April 7, 2021

RE: Approval of Best Management Practices for 2021 Beach Nourishment Dredged Materials Placement Activities along the Northern Portion of Lake Superior side of Minnesota Point in Duluth, Minnesota

Figure 2: 2021 Minnesota Point Beach Nourishment Placement Site and Project Area.

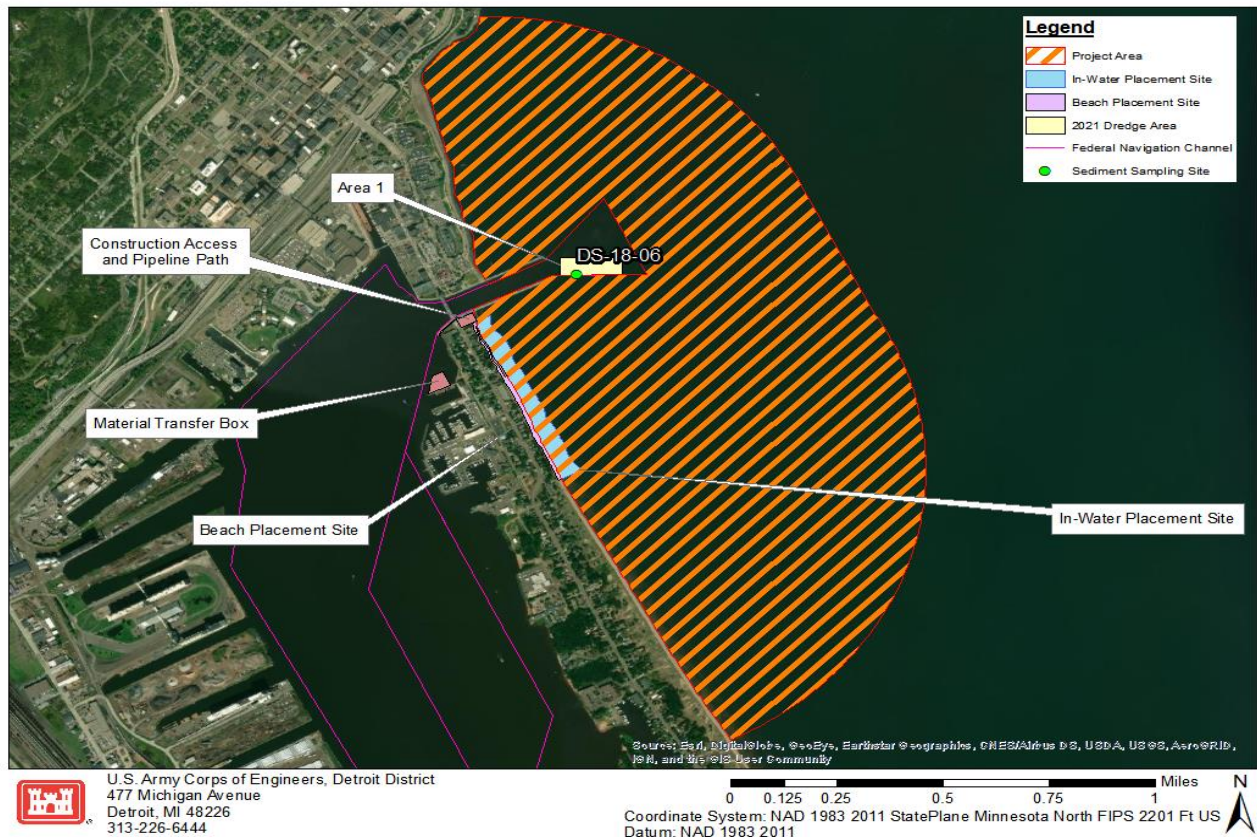
- 4. Dredged Material Must Only be Placed Within the Project Site Placement Limits as Shown in Figure 2, Above, and as Further Described in the Final Plans and Specifications for the Project.** To ensure material placement occurs within specified limits, the USACE must verify placement locations during quality assurance inspections and use sounding baskets to check depths.

Horizontal Discharge Pipe with Baffle Plate

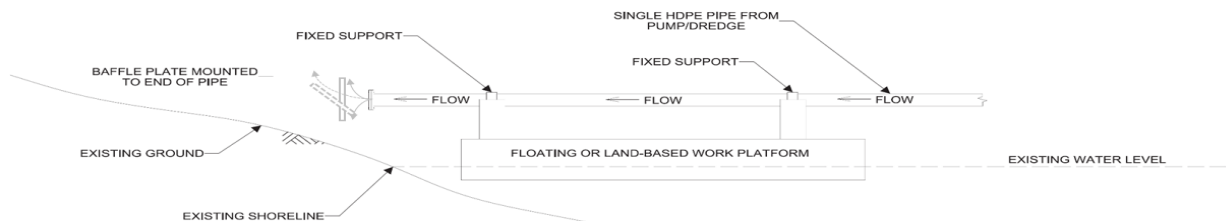
8. **Material Placement Configuration for Hydraulic Placement:** A single horizontal discharge pipe with baffle plate configuration must be employed during the 2021 hydraulic placement of material at the placement site. A maximum of a 16" hydraulic pump/dredge and 16" HDPE pipe must be used. The vertical baffle plate that must be mounted to the outlet of the pipe must be at least twice the diameter of the discharge pipe and must dissipate the energy of the effluent in such manner as to maximize sediment settling rates. The baffle plate may be attached perpendicular to the pipe flow, as illustrated below, or at no greater than a 45 degree angle to facilitate directing the placement of material upward and away from the water. The exact positioning of the baffle plate will be configured to maximize the sediment settling rates based on the flow and slurry characteristics. The contractor must use only one discharge pipe during placement activities. Splitting or otherwise separating the flow at any point along the length of the discharge pipe is strictly prohibited.
